Submissions Report
New High School in Bungendore
SSD-14394209

On behalf of
NSW Department of Education
September 2022

Plans at
Lodgement
(Drawing
No. AR DA
HS-1010,
Revision A)

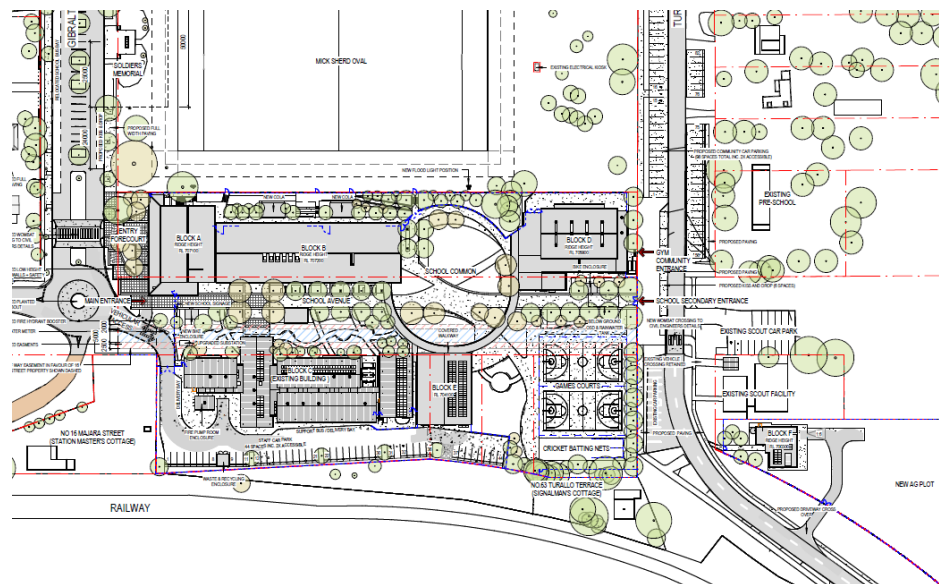
- Amendment to the layout and design of the school buildings including relocation of buildings and sporting facilities, reducing bulk and scale, amending the colours and finishes, and removal of the community facilities which are being provided by Council through a separate planning process on a separate site.

- The original alignment of Majara Street has been reinstated within the revised design. The built form and landscape design have been amended to acknowledge and reinforce the original street alignment. The relocation and redesign of the built form from the Majara Street axis retains the site's existing visual connection with Turallo Creek to the north.

Amended
Plans
(Drawing
No. AR DA
HS-1010,
Revision C)

Revised Landscape Scheme

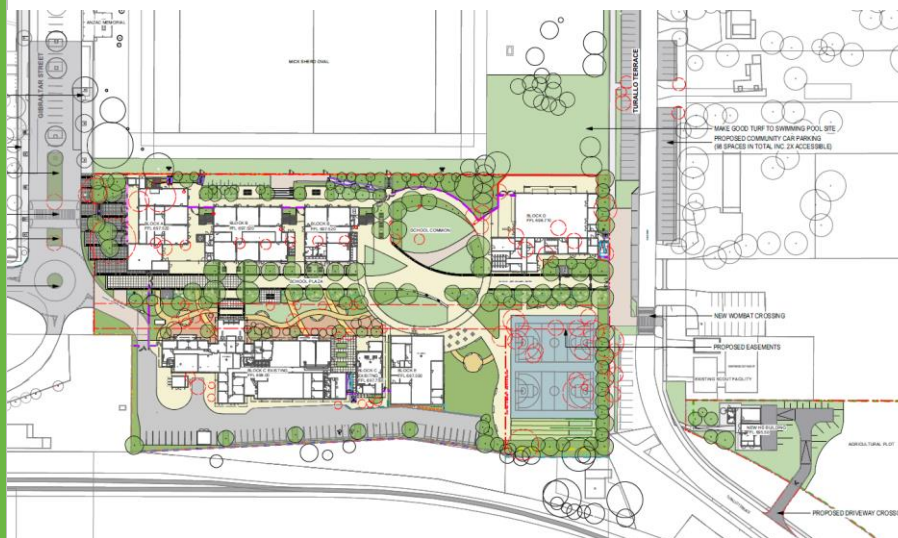
- Amendment to the landscaping scheme with additional planting, relocation of covered walkways, removal of bollards and fencing around Mick Sherd Oval and the war memorial, and provision of a through-site connection between the school plaza and Mick Sherd Oval.

It was also requested during the consultation process that the accessway fronting the new roundabout at Gibraltar and Majara Streets be landscaped with native plants. The revised Landscape Plans incorporate native grasses and shrubs outside of trafficable areas.

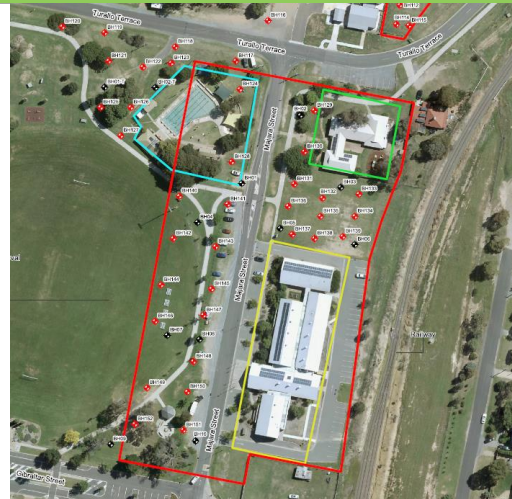
<p>2. Contamination</p> <p>The submitted Preliminary Site Investigation (PSI) identifies that additional site investigations are required to be undertaken on the agricultural plot. A Detailed Site Investigation (DSI) is required to be submitted and must include the additional site investigations recommended in the PSI. If the DSI concludes that remediation is required, a Remediation Action Plan (RAP) is also required to be submitted. The RAP must be prepared in accordance with the EPA's Consultants reporting on contaminated land: Contaminated land guidelines (2020).</p> <p>Since the Application was lodged, Transport for NSW (TfNSW) has identified lead contamination in soil along the rail corridor at Bungendore.</p> <p>Please ensure the technical consultant addresses these recent lead contamination findings in the requested DSI.</p>	<p>Since the PSI was undertaken by Douglas Partners Pty Ltd (DP) as reported in 'Report on Preliminary Site Investigation (Contamination), New High School in Bungendore' (report ref 202107.03.R.001.Rev2), dated 7 September 2021), DP has completed a Detailed Site Investigation for the site, including the agricultural plot.</p> <p>The DSI comprised drilling of 52 locations in addition to the 12 locations undertaken as part of the PSI (DP, 2021). The borehole locations undertaken with the PSI are identified by the black markers in the plan below, and borehole locations undertaken with the DSI are identified by the red markers.</p>

Following receipt of Environmental Resources Management Australia Pty Ltd (ERM) PSI of the rail corridor (reported in Preliminary Site Investigation, Bungendore Rail Corridor, report ref: 0608750.Rev03, dated 2 March 2022 (ERM, 2022)), and ERM PSI of the Bungendore Rail Station (report in Preliminary Site Investigation, Bungendore Rail Station, report ref 0608750.Rev0, dated 3 May 2022 (ERM, 2022a)) the DSI completed for the Bungendore High School has been revised to incorporate the findings of ERM reports (2022 and 2022a). The revised DP DSI is detailed in 'Report on Detailed Site Investigation (Contamination), Proposed New High School in Bungendore' (report ref 202107.04.R.002.Rev2), dated 14 July 2022.

The DSI concluded that *'it is considered that the site is suitable, from a contamination perspective for the proposed development'*. In addition, the following recommendations were made:

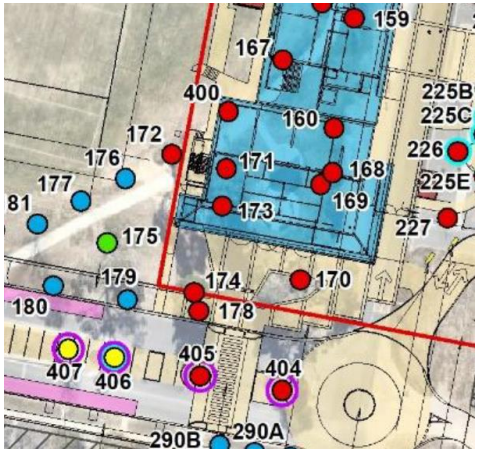
<p>In the location of trees 170 and 171 are shown in the landscape drawings but the survey only shows one tree. Please address the inconsistency.</p>	<p>Collaboration between the surveyor and arborist has been undertaken to ensure all relevant trees have been identified. The definition of a tree is in accordance with AS4970 which identifies a perennial plant greater than 3 metres in height with one or few main stems or trunks. The survey and arborists report have been updated to account for this definition and identify all trees on the site.</p>
<p>The AIA shows that tree 171 is the largest high value retention tree but it is proposed for removal. Please clarify whether it is proposed for removal and if so, please amend the proposal to retain this tree or alternatively justify its removal.</p>	<p>Tree 171 is proposed for removal due to the high impact as a result of the development. The below extract from the updated AIA identifies Tree 171 as being within the footprint of Block A and is therefore required to be removed.</p>

Figure 1: Outdoor Play Space and Future Expansion Details

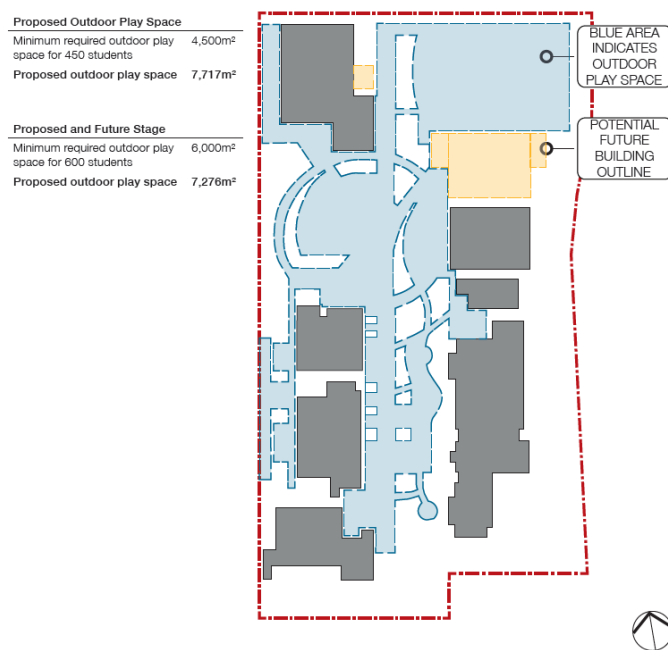
The teaching spaces in the proposed high school in Bungendore are sized to accommodate 450 students, and the core facilities are sized to accommodate 600 students in case of future expansion. Therefore, even accounting for future expansion, it is clear that the required site area is much less than 4ha.

The site provides outdoor open space in accordance with the Educational Facilities Standard and Guidelines (EFSG's) benchmark of 10sqm of open space per student, with additional space provided in case of future expansion. Based on 450 students, a total area of 4,500sqm would be required. The amended design provides a total of 7,717sqm of outdoor play space as illustrated in Figure 1 below.
